FROM:	G. KOTSIFAS, P.ENG. MANAGING DIRECTOR, DEVELOPMENT & COMPLIANCE SERVICES & CHIEF BUILDING OFFICIAL
SUBJECT:	REQUEST FOR EXTENSION OF DRAFT APPROVAL LANDEA DEVELOPMENTS INC. 995 FANSHAWE PARK ROAD WEST 39T-05512
	MEETING ON FEBRUARY 22, 2016

Draft Plan Extension
39T-05512

Conditions to be included for Draft Plan Approval (Deleted conditions Strikeout New Conditions in BOLD ITALIC LETTERING)

Draft Plan

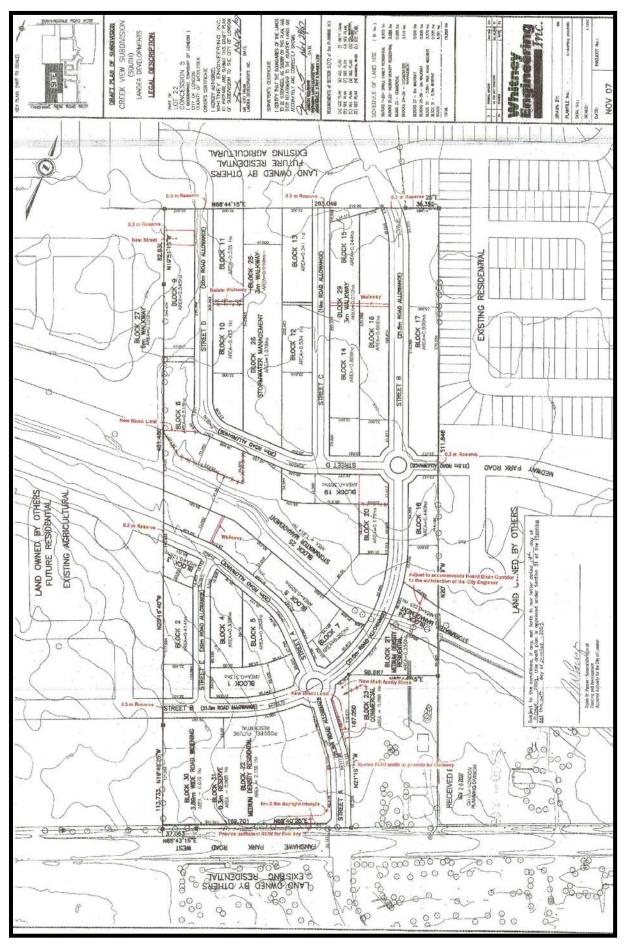
A condition (119) has been added to the revised Draft Plan Conditions requiring that this road extension to connect Aldersbrook Gate and Medway Park Drive be included in the next phase for subdivision approval.

The attached amendments to the conditions of draft approval are required to ensure that these lands are developed to today's standards. The changes to conditions are to address engineering issues. The amendments to the conditions of draft approval are shown as strikeouts (deletions) and **bold italic lettering** (additions) on the attached Appendix. If granted, the new draft approval lapse date would be October 14, 2018.

- 118 Prior to the issuance of any Certificate of Conditional Approval, the Owner shall implement the approved servicing, if necessary, for the street townhouse units on any streets in this plan, to the satisfaction of the City Engineer.
- 119 The Owner shall include and construct the streets from Aldersbrook Gate to Medway Park Drive in the next phase of subdivision approval.
